Ref. ID ADHOC-D-26-02099
"Onset-Anchored Selective Computation for Resource-Constrained Vehicular Edge Networks"
(submitted as "Trustworthy Selective Computation for Resource-Constrained Vehicular Edge Networks"; retitled in this revision, see R3.7)

Response to Reviewers*

*For the manuscript, Ref. ID ADHOC-D-26-02099, "Onset-Anchored Selective Computation for Resource-Constrained Vehicular Edge Networks" (submitted as "Trustworthy Selective Computation for Resource-Constrained Vehicular Edge Networks").

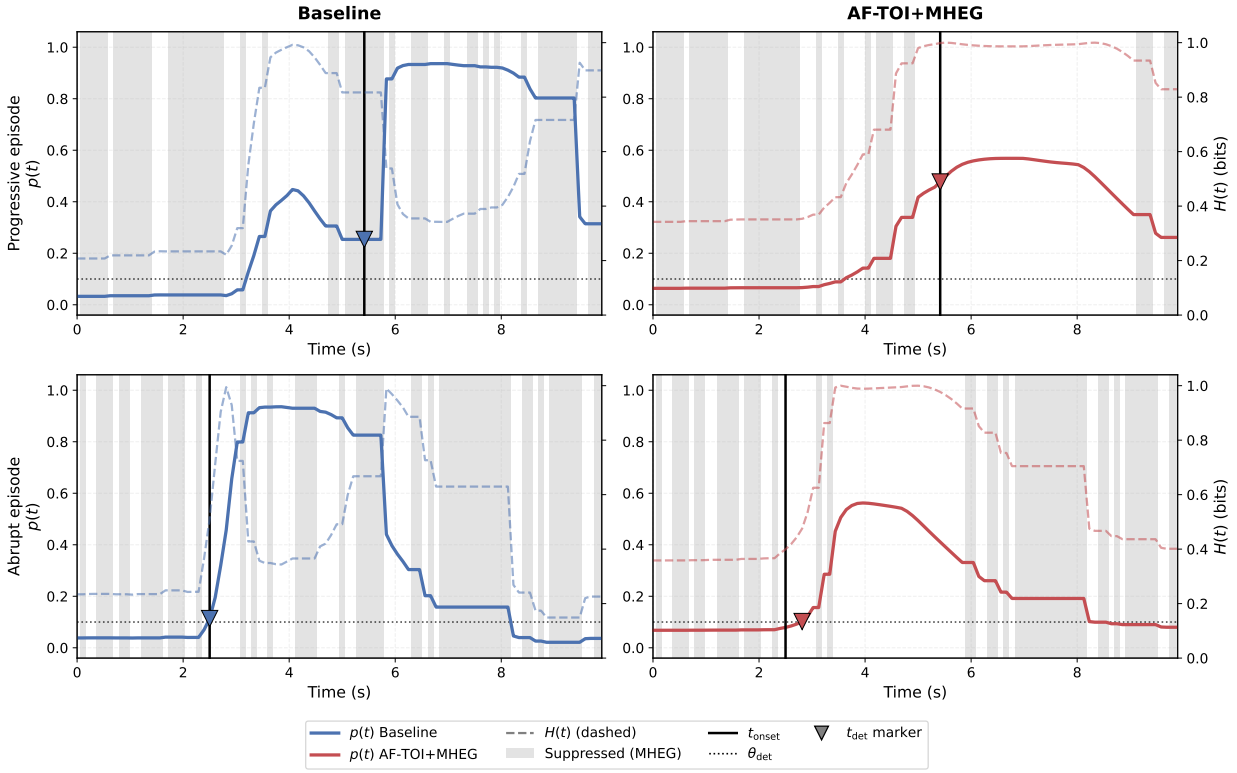
6. Comment: Frame-by-frame temporal evidence for seed 42 graph is not explained well.

Response: We agree with the reviewer. A frame-by-frame reading guide has been added to the paragraph following the first mention of Figure 5 in Section 4.2, identifying each visual element of the seed-42 examples. During revision verification we also found and corrected two problems in this figure: (a) the exemplar episodes of the submitted version were not selected by a stated criterion, and the abrupt exemplar was atypical (it belongs to a saturated minority of episodes whose entropy sits near the maximum throughout); the figure now uses, per regime, the episode with the *median* pre/post-onset entropy contrast among seed-42 critical episodes with central onset, and the caption states the criterion; (b) the replay that produced the suppression shading applied the entropy threshold in the wrong logarithm base (natural log instead of the base-2 entropy of Eq. 13), so the entropic branch of the gate never fired in that log; the log was regenerated with the correct base, and the entropy axes of Figures 4–6 are now uniformly in bits, matching Eq. 13. The added text

(The full frame-by-frame reading guide follows the first mention of Figure 5 in Section 4.2.) Its selection criterion reads: "The exemplars are selected by a pre-declared neutral criterion: within each regime, the episode whose pre/post-onset entropy contrast is the *median* among the critical episodes of seed 42 with a centrally located onset (progressive: episode 36, t_0=5.42 s; abrupt: episode 148, t_0=2.50 s)." The guide also states that detection markers of single exemplars do not arbitrate latency (aggregate latencies are settled by Table 8) and that a minority of abrupt critical episodes (12 of 48 in seed 42) runs near maximal entropy throughout. The regenerated figure is reproduced below.

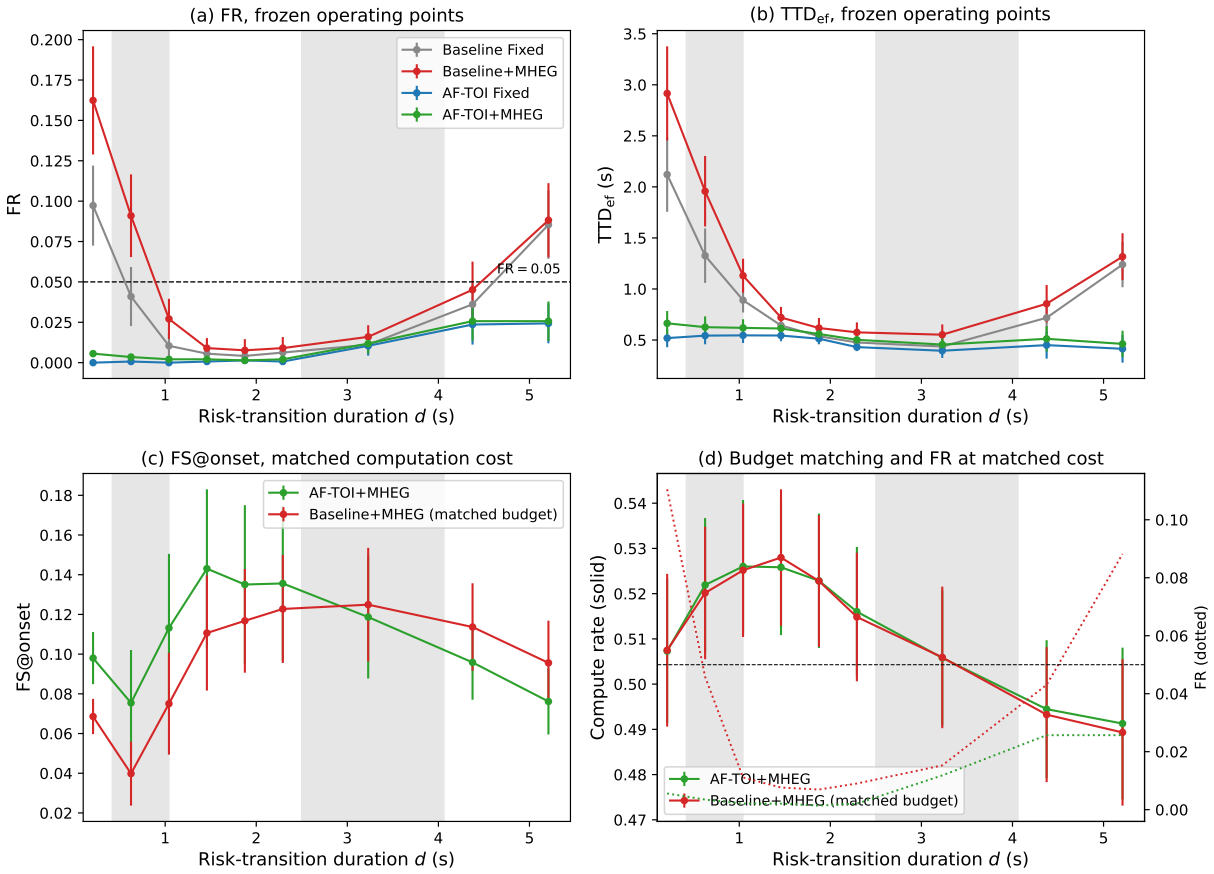
4. Comment: A central claim of the study is that temporal organization of uncertainty is important for safe selective computation, but the current experiments appear to be strongly tied to the risk-transition patterns defined by the experimental setup. The authors should investigate whether AF-TOI generalizes to unseen temporal risk trajectories, different onset durations, abrupt versus gradual transitions, intermediate-risk conditions, changes in the distribution of input features, or distribution shifts between training and testing conditions.

Response: We agree with the reviewer. To address the question of generalization across different transition durations, a new temporal-scale experiment has been added in Section 4.12, together with Figure 14 and Table 21. The experiment varies the risk-transition duration independently through a shape-preserving temporal warp while keeping t_0, the normalized transition shape, the episode context, the model weights, and the scheduler thresholds fixed. The limitations paragraph of Section 5 was also revised to distinguish this controlled temporal train–test shift from broader naturalistic distribution shift. The six aspects raised in the comment are addressed as follows.

(ii) *Different onset/transition durations* are evaluated by the new experiment of Section 4.12, across nine durations from 0.21 to 5.21 s, including interpolation and extrapolation outside the training support.

"Figure 14a–b and Table 21 report the frozen operating points. AF-TOI maintains mean FR below 0.05 at every evaluated duration under both policies: for the fixed policy (Table 21) the maximum duration-wise mean FR is 0.024 with $\mathrm{TTD}_{\mathrm{ef}}$ within approximately 0.40–0.55 s, and for AF-TOI+MHEG (Figure 14a–b; per-duration values in the artifact) the maximum duration-wise mean FR is 0.026 with $\mathrm{TTD}_{\mathrm{ef}}$ within approximately 0.46–0.66 s. The Baseline crosses mean FR = 0.05 at both extrapolation extremes (mean FR 0.097 at 0.21 s and 0.085 at 5.21 s for the fixed policy), and its $\mathrm{TTD}_{\mathrm{ef}}$ follows a U-shaped profile that reaches 2.12 s at the fast extreme. At the level of individual seed×duration cells, AF-TOI exceeds FR = 0.05 in 7 of 108 cells (all at $d \geq 3.23$ s, maximum 0.108), against 22 of 108 for the fixed Baseline (maximum 0.250) and 32 of 108 for Baseline+MHEG (maximum 0.333). Frame-level F1 remained seed-sensitive under the warp, a pattern consistent with checkpoint-level variability rather than with an effect of the warp itself. Accordingly, the result is restricted to aggregate coverage and effective delay and does not constitute a per-seed guarantee: AF-TOI shows aggregate temporal-scale robustness across the evaluated synthetic range of unseen risk-transition durations." (Section 4.12, frozen-operating-points paragraph)

"Because the two frozen gates suppress different fractions of frames, we added a post-hoc matched-budget diagnostic: for each seed×duration cell, the entropy threshold of Baseline+MHEG was adjusted by bisection (...) until its computation rate (fraction of executed window updates; both arms share the recompute semantics of Section 3.4) matched that of AF-TOI+MHEG on the same cell (all 108 cells matched within 1.9%, tolerance 2%; Figure 14d). (...) At matched computation cost, no systematic FS@onset advantage remains (...). Under Holm correction within each endpoint family, only the $\mathrm{TTD}_{\mathrm{ef}}$ difference at 0.21 s remains significant ($p = 0.031$), so these per-duration matched-cost contrasts should be read as exploratory. The matched-budget diagnostic supports a temporal-scale coverage-and-timeliness advantage, not a universal improvement in near-onset suppression placement." (Section 4.12, third paragraph)
